**West Virginia Community and Technical College System
West Virginia Northern Community College – Renovations at Weirton
and New Martinsville Campuses
M&G Project No. 18-053.1 and 18-053.2
Request for Bids No. 19019**

ADDENDUM NO. 1
August 20, 2018

SHEET
 ADD01
 SKA01

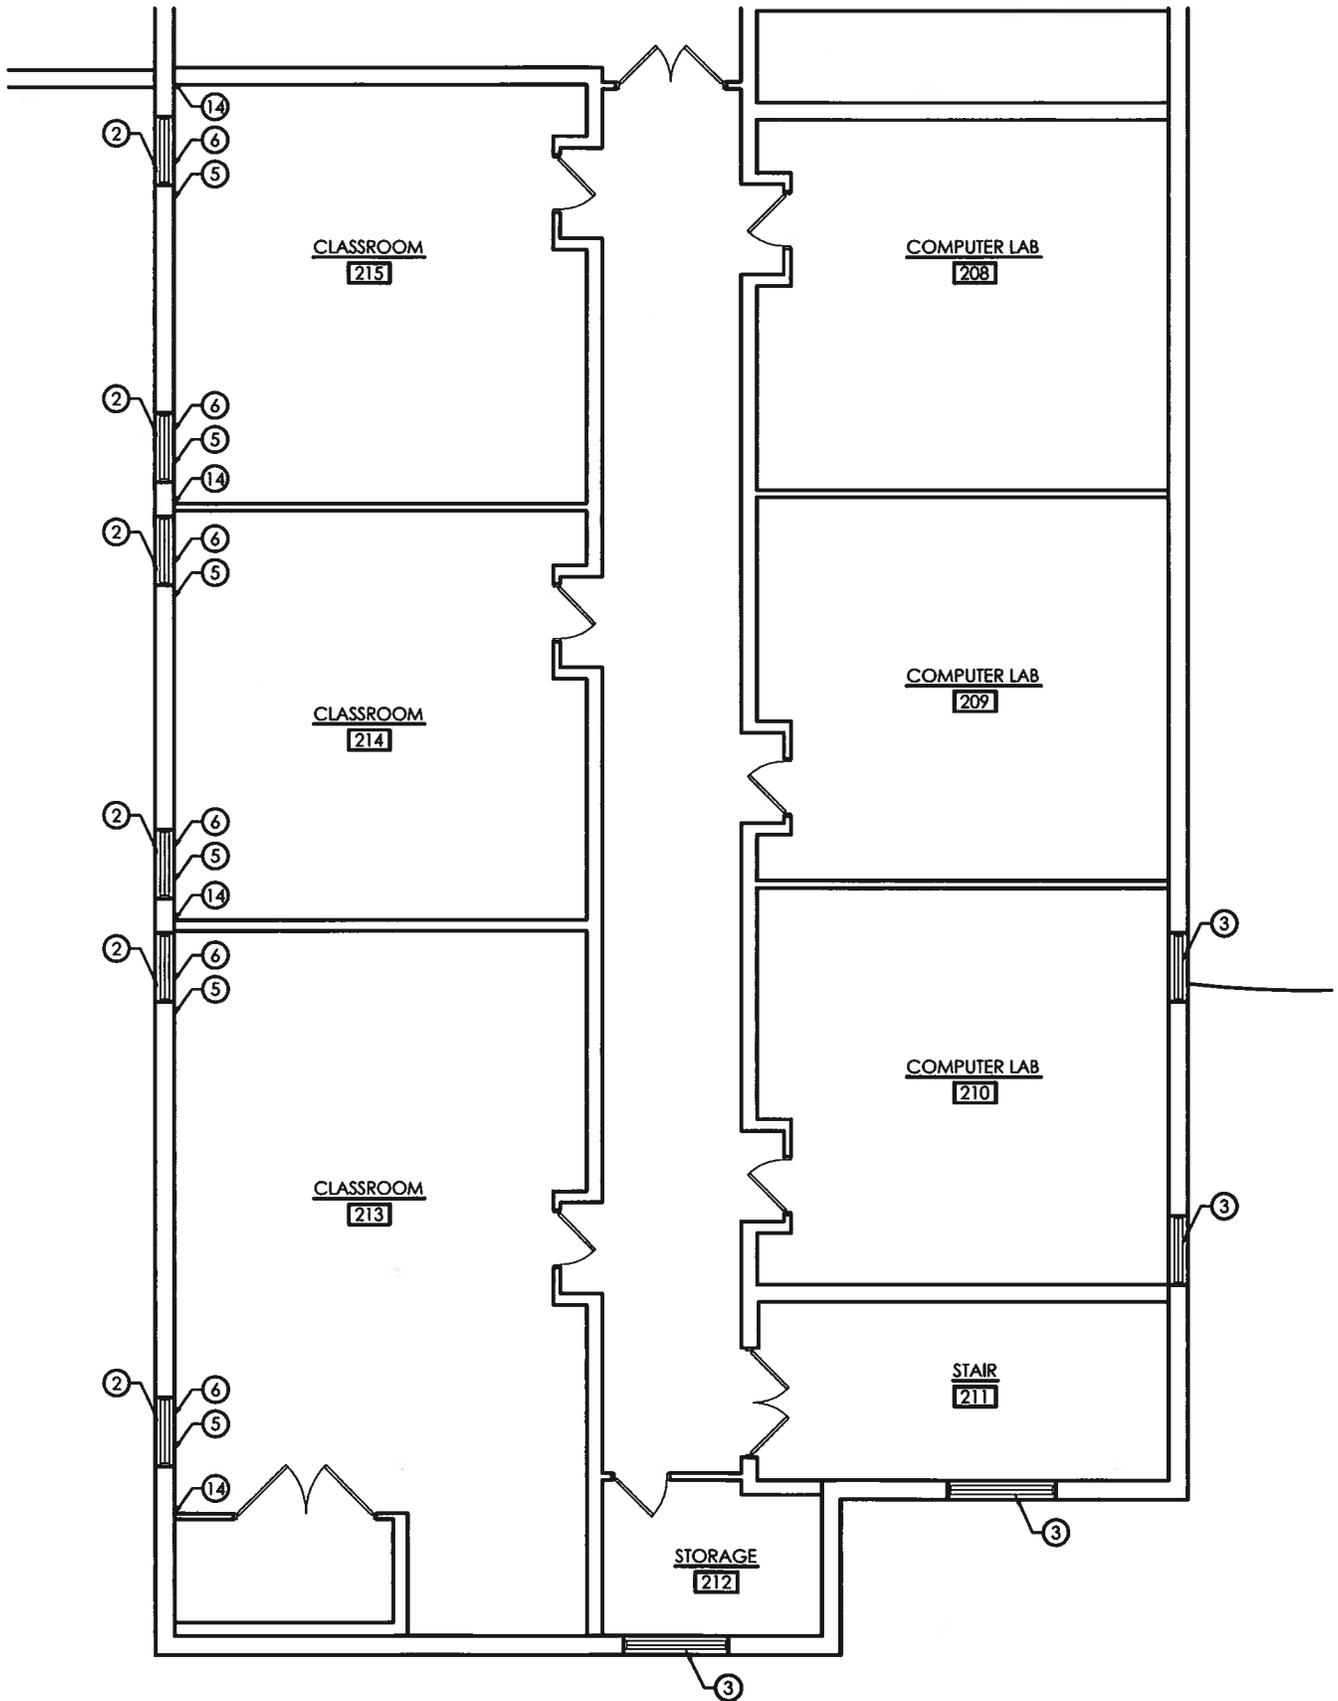
- H. Reference attached sketches ADD01-SKA01 and ADD01-SKA02 for existing room numbers, as well as, patching and painting of gyp. bd. walls adjacent to the lintel work at the Weirton campus.
